ADDENDUM NO. 1 - TO ALL PLAN HOLDERS OF RECORD

**MAINE-ENDWELL CENTRAL SCHOOL DISTRICT
2022 Capital Improvement Project – PHASE 4
Senior High School– SED # 03-11-01-06-0-010-030**

KING + KING PROJECT # 23-44-7954

ADDENDUM 1

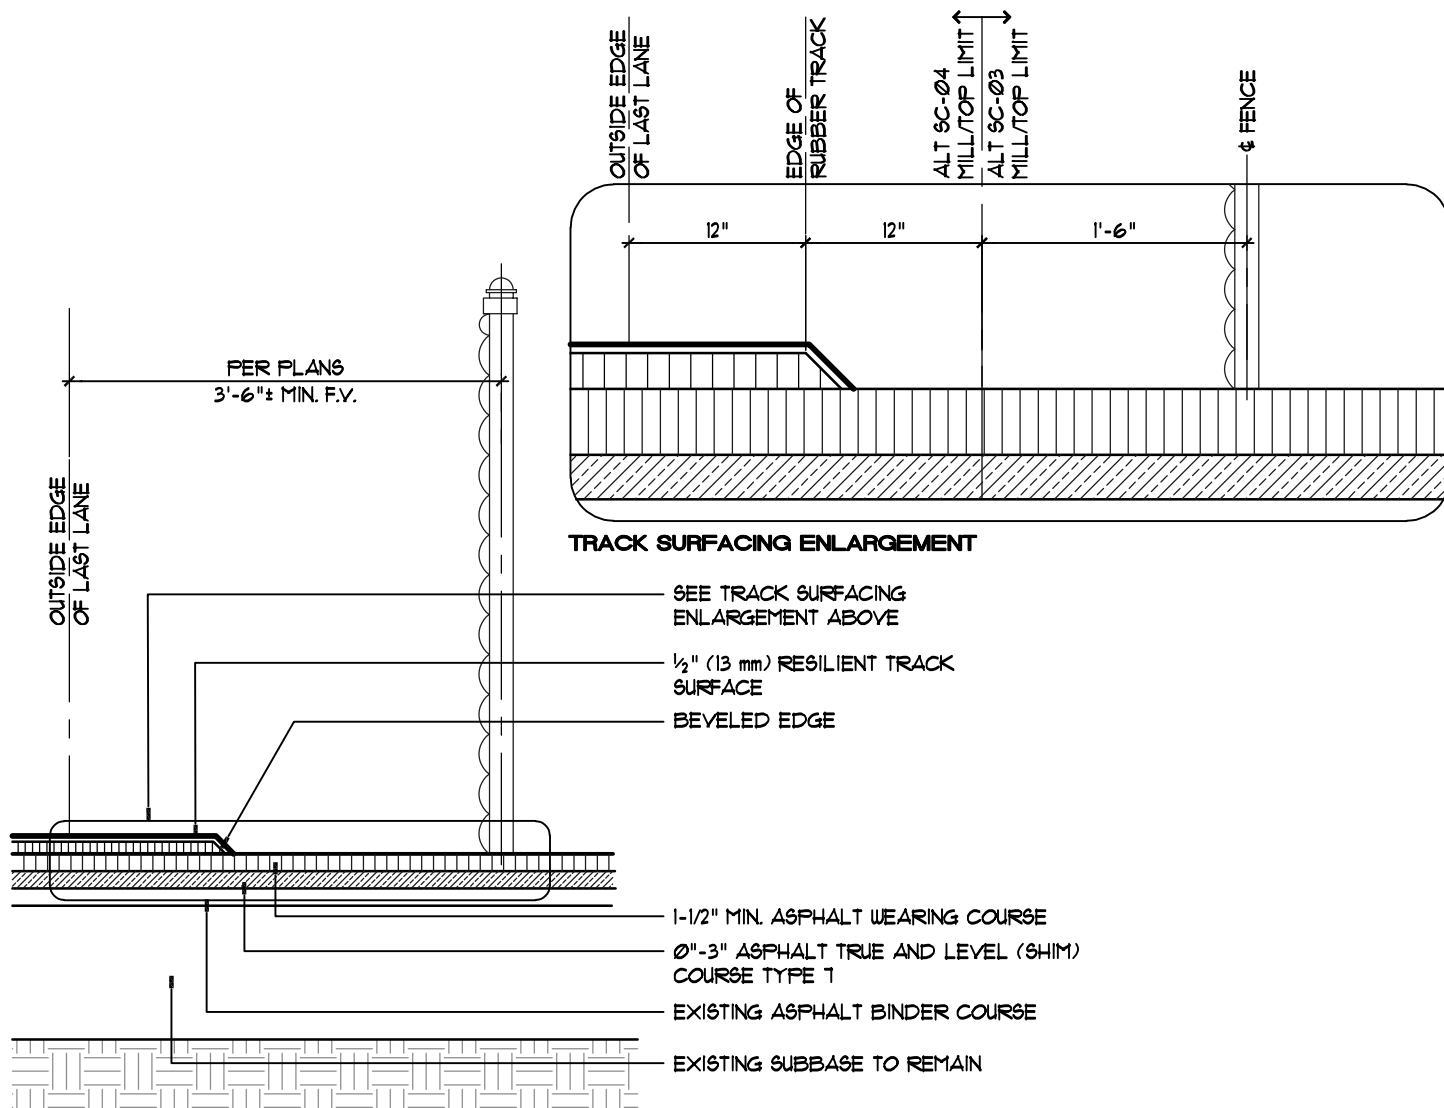
accepted. Note: Detail 3/L9.02 will be updated to clarify milling alternate limits in relation to fence location. Any replacement of fence posts (outside of construction access) will be addressed through change order/allowance during construction.

1. AD1-L01 – Resilient Track Surface RTS Mill/Top detail 3/L9.02 shall be **REPLACED** with AD1-L01 to clarify mill/top limits for Alternates SC-03, Alternate SC-04 and track surfacing limits.
